Soli Khericha

Review

SFP RISK AT DECOMMISSIONED PLANTS

INTERNAL FIRE INITIATING EVENT

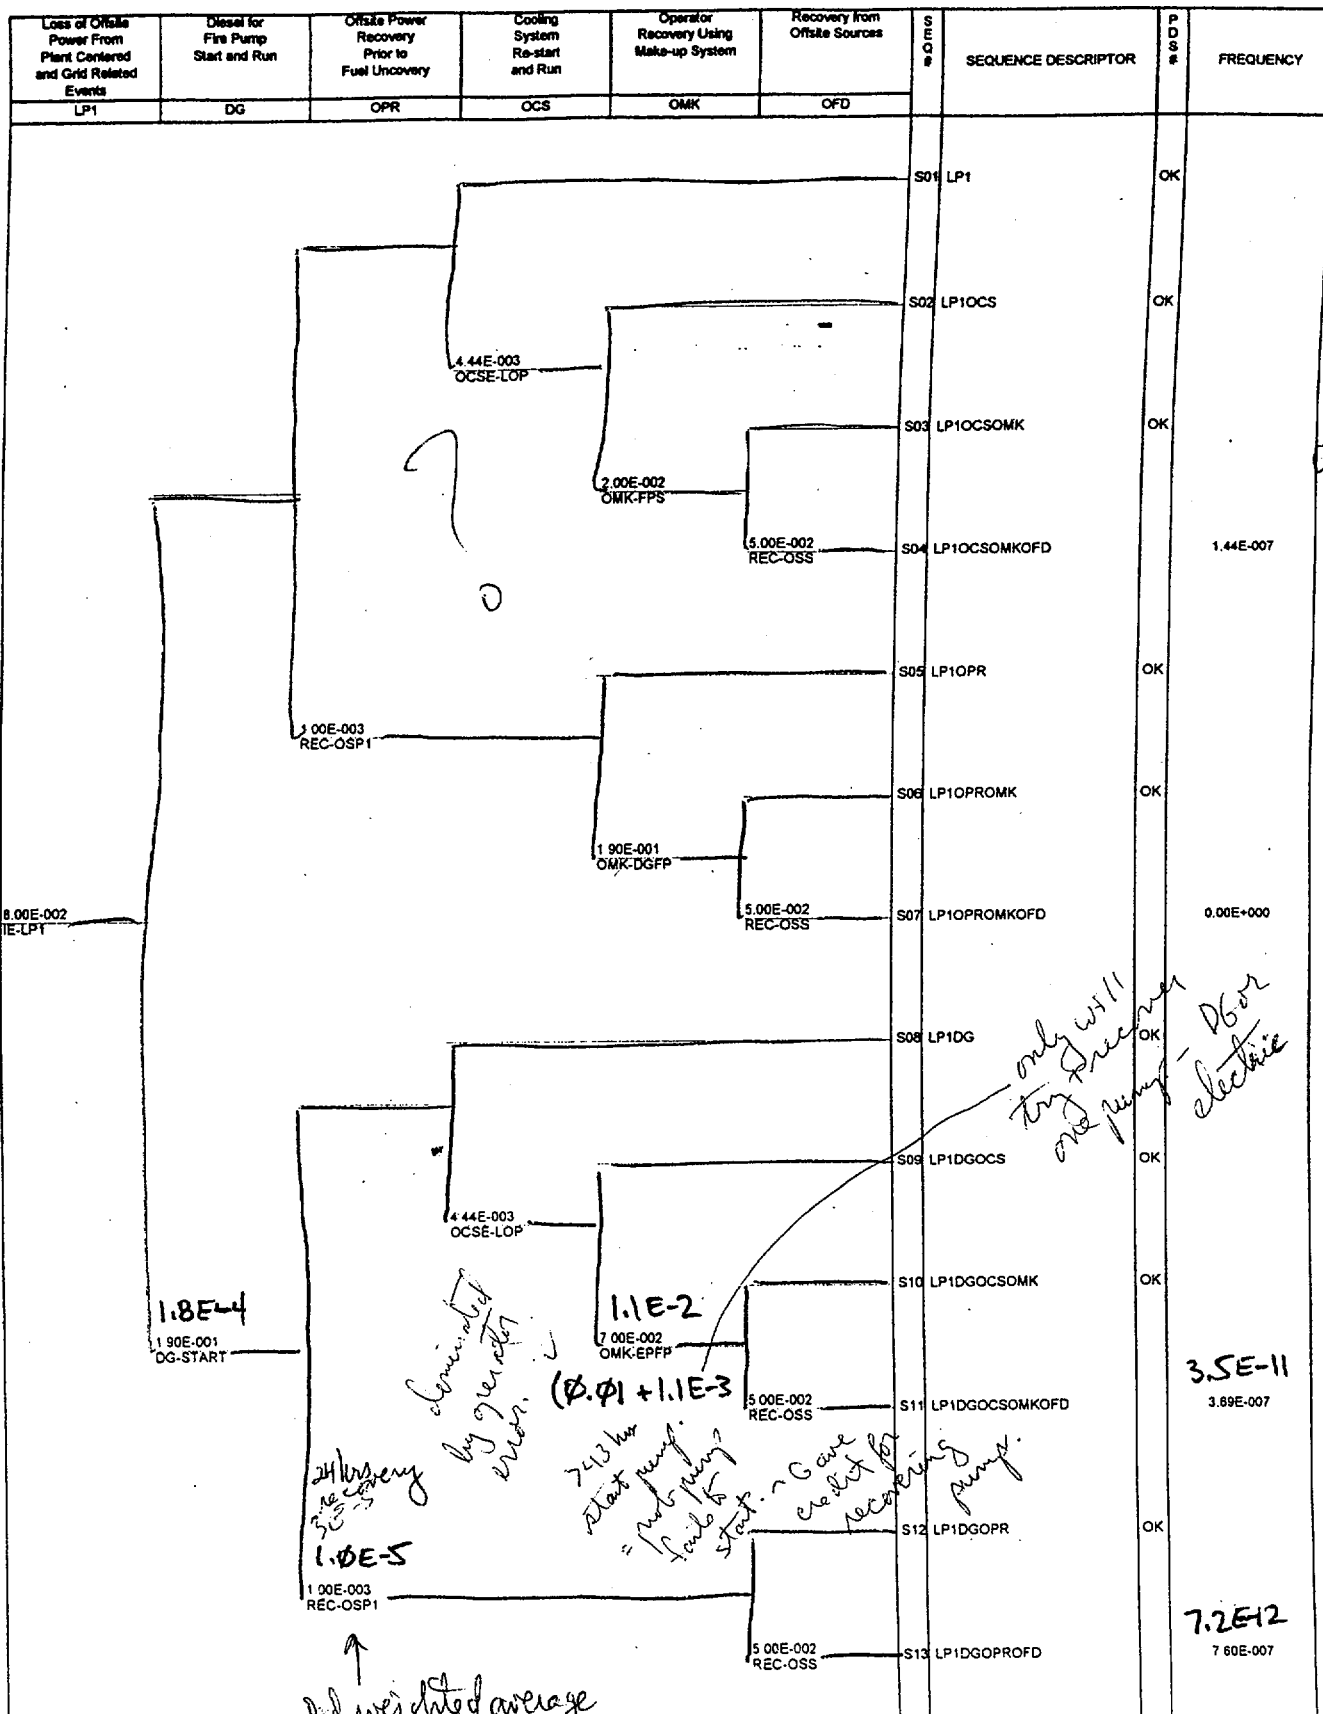
→ electric fire water pump failure rate.
.06 Failure to start + run

Where does it come from

LOSS OF OFFSITE POWER
FROM PLANT CENTERED EVENTS
CASE 1

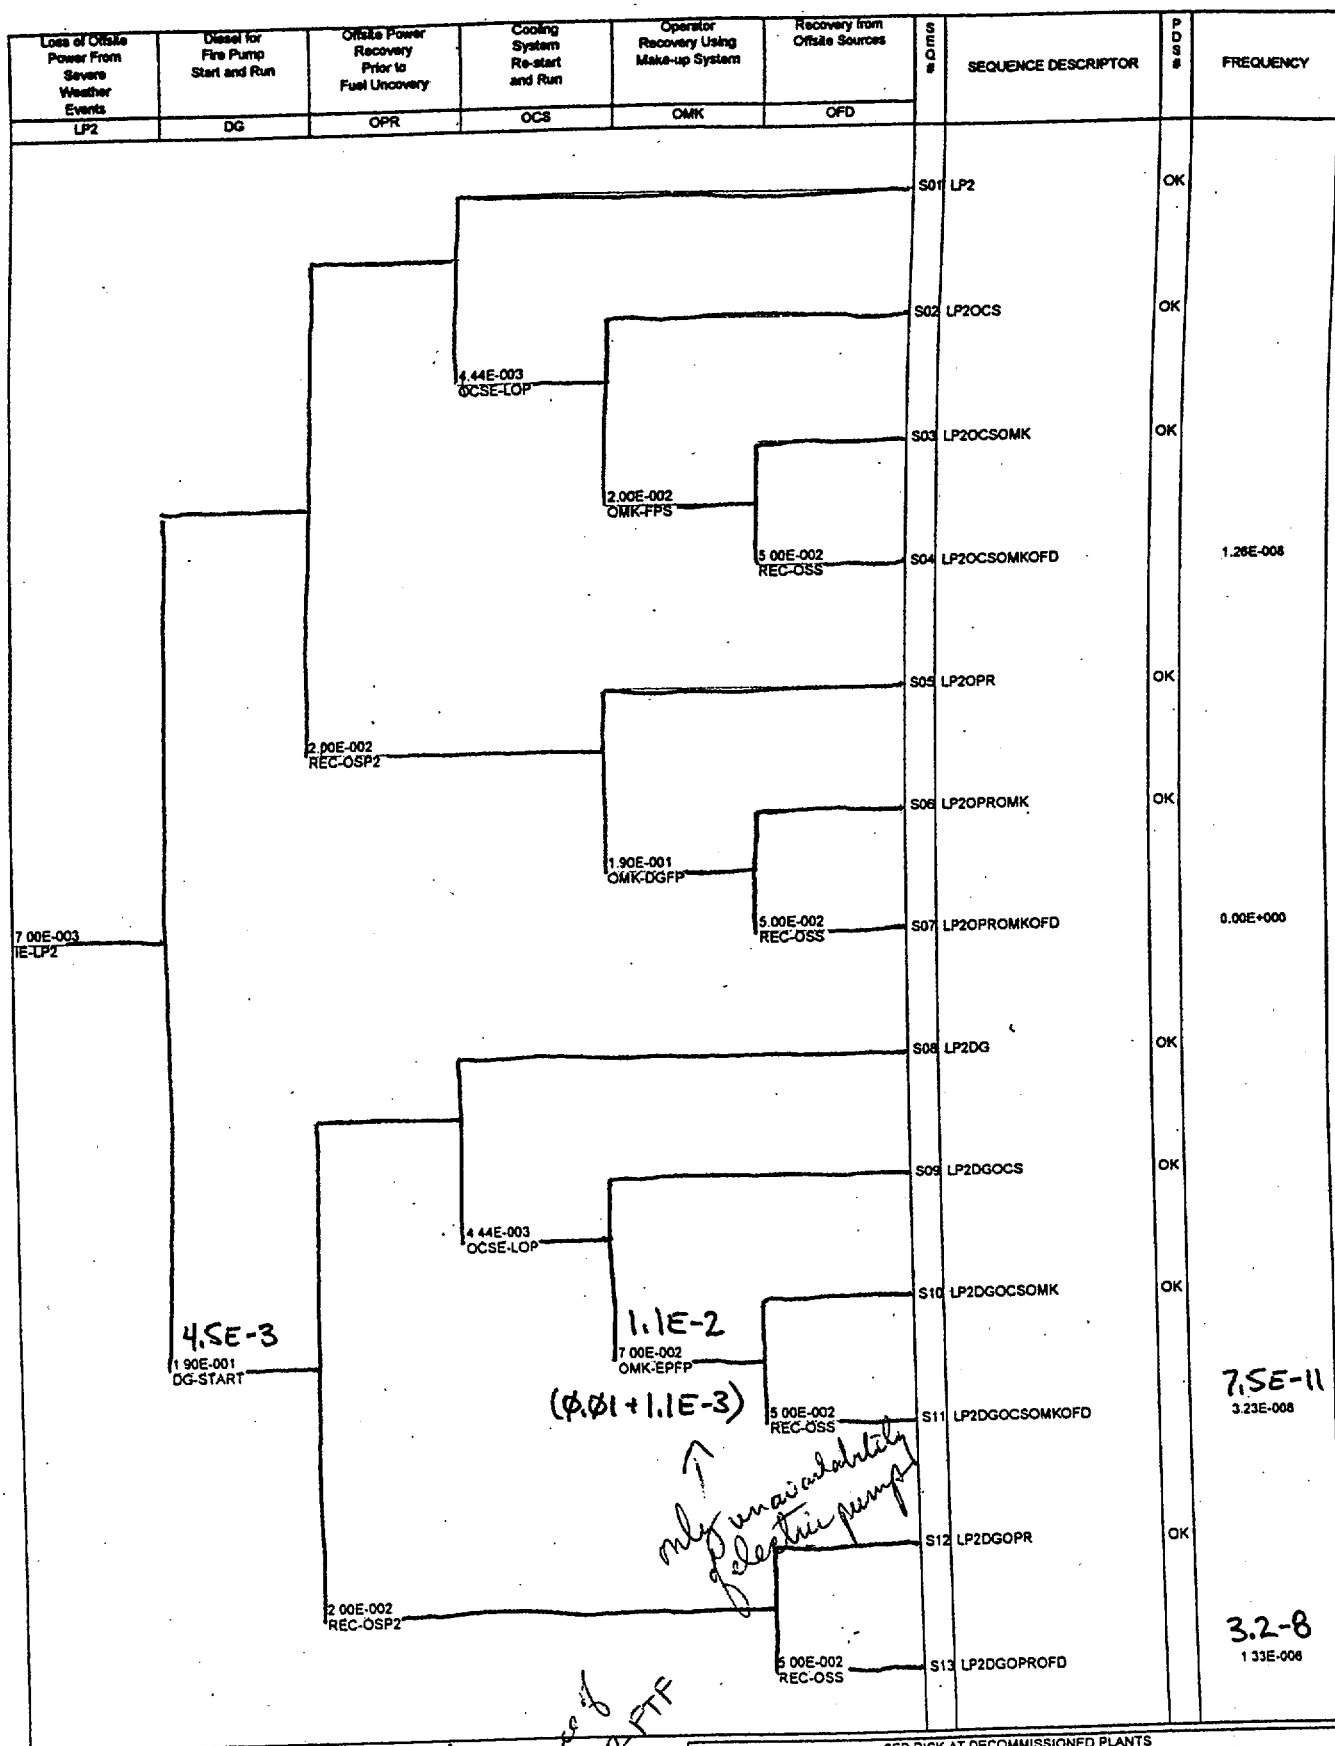
See pg 20

LOSS OF OFFSITE POWER
FROM SEVERE WEATHER EVENTS

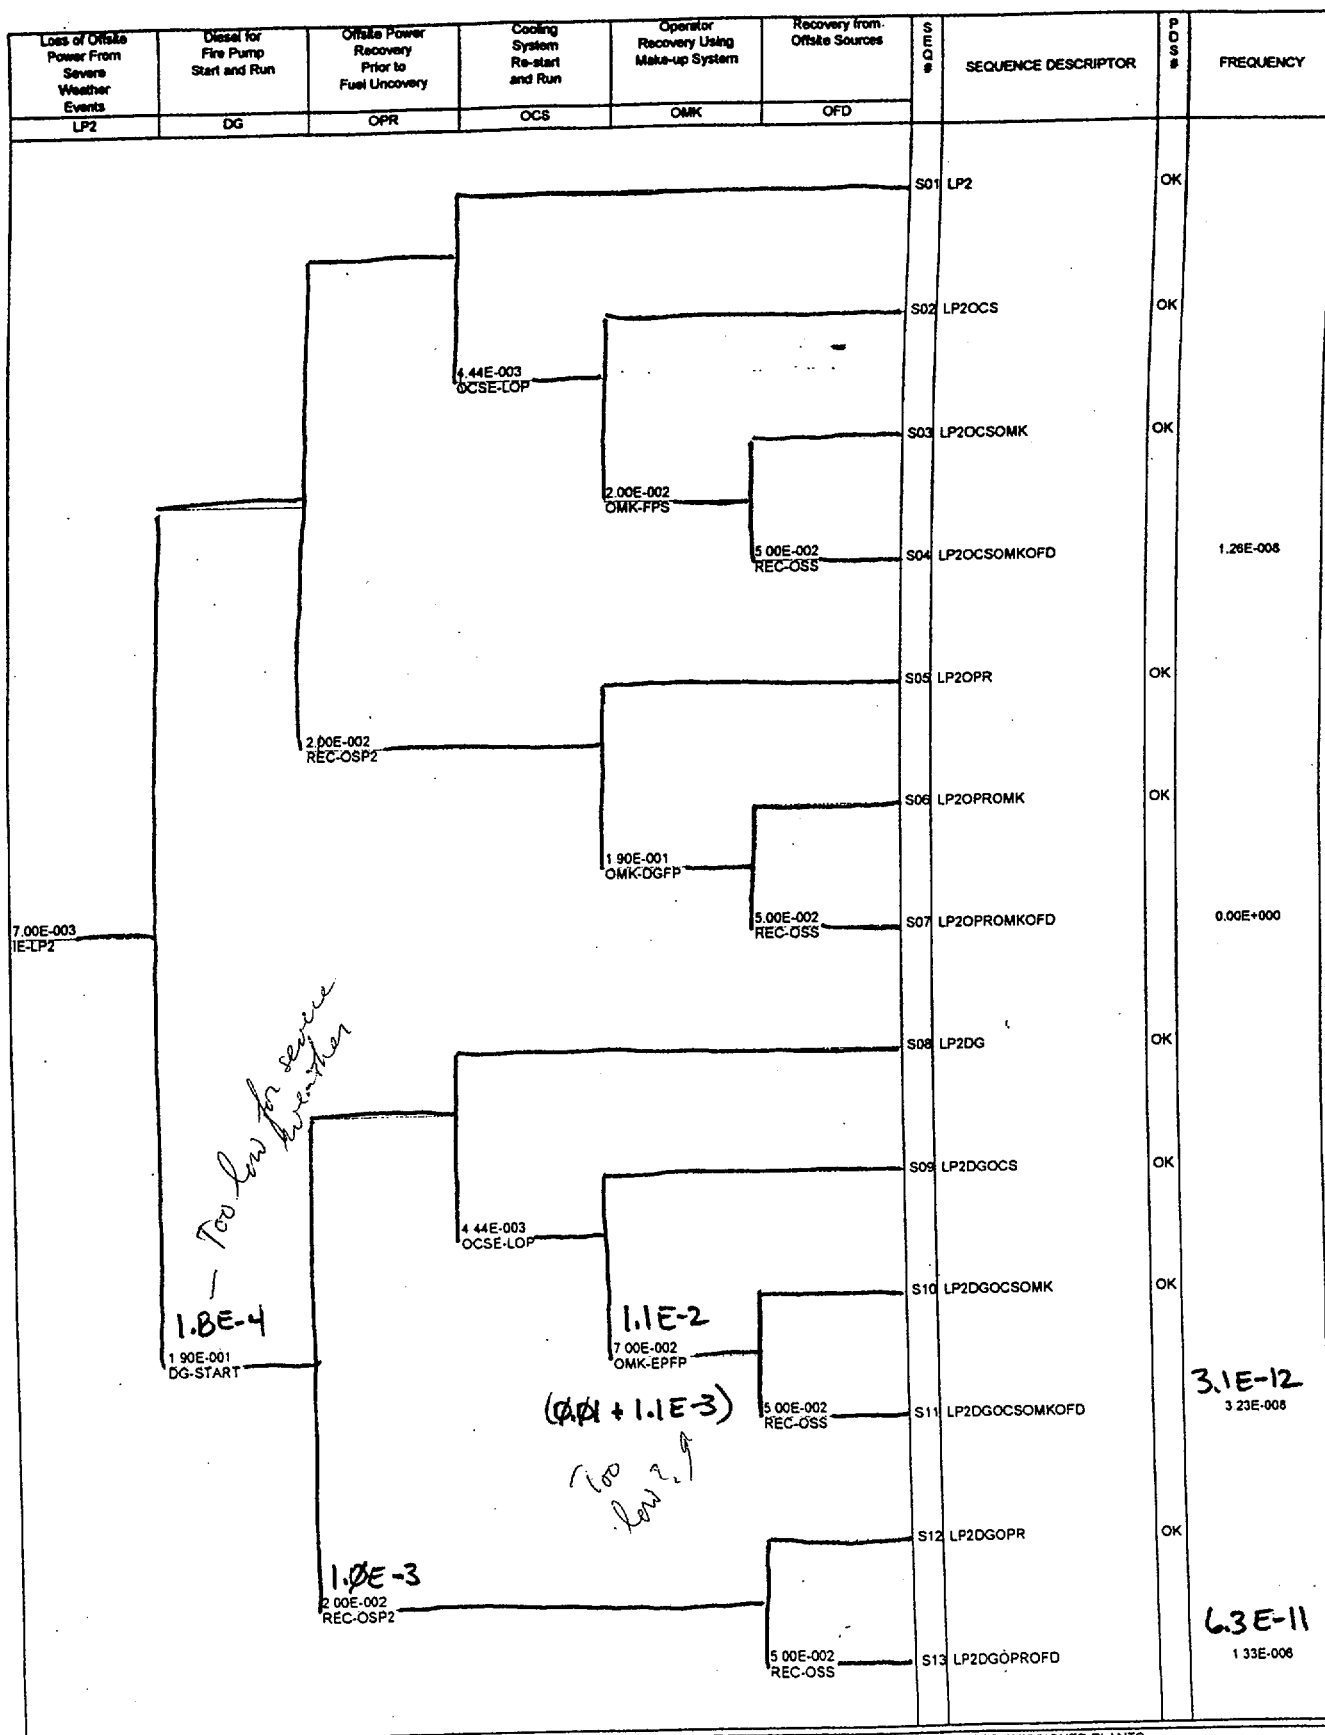
See Appendix A-1
What is source of
FP - EL PUMP - FTF

only availability
of electric pumps
